CONSTRUCTION SUMMARY

Mountainview Heights 3 (G) - Russell Gardens Building Ltd.

LOT / PHASE	REG. PLAN #	HOUSE TYPE		
221 / 3	62M-1266	Mountainash Three (5 Bedroom) Elev 3

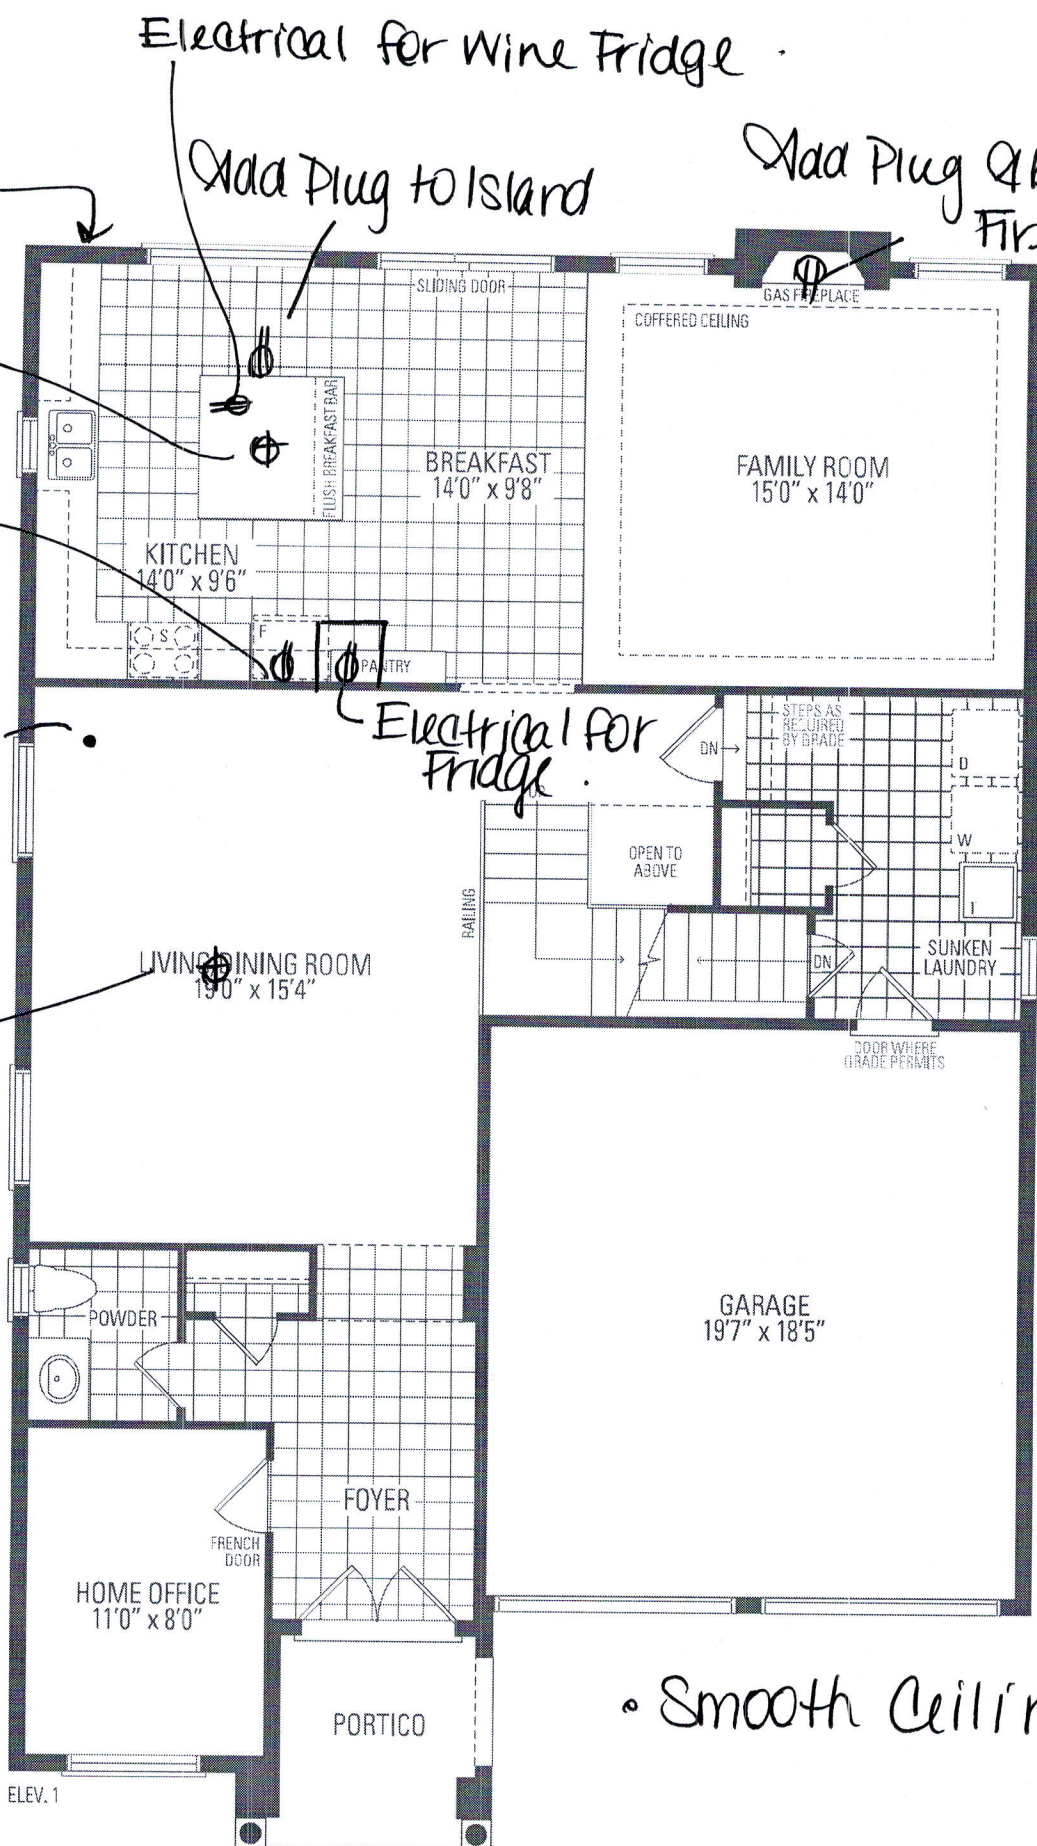
Gas Line
for BBQ

Electrical for Wine Fridge

Add Plug to Island

Add Plug Above
Fireplace

Add Light
Above Island

Electrical for
B-I Oven/micro

Add Potlight

Electrical for
Fridge

Center Std
Light

• Smooth Ceiling •

MOUNTAINASH THREE

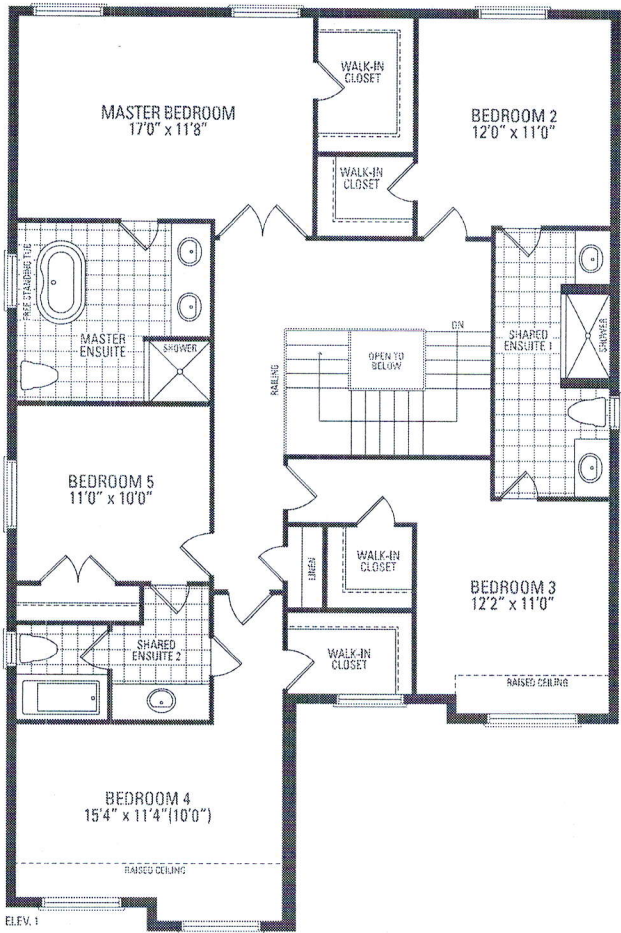
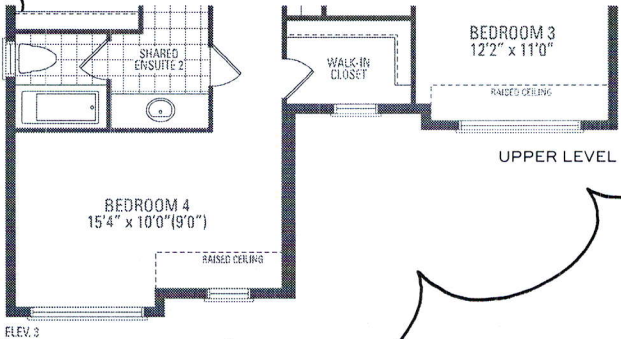
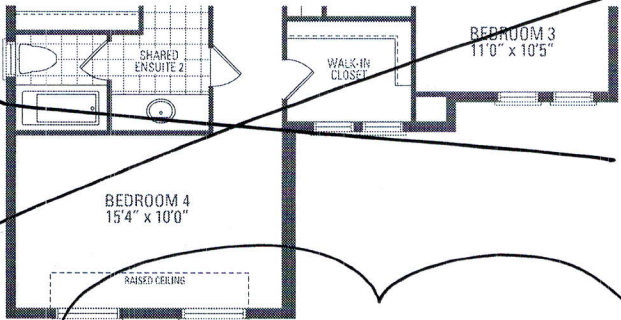
Add Plug 5'
from floor for
future tv.
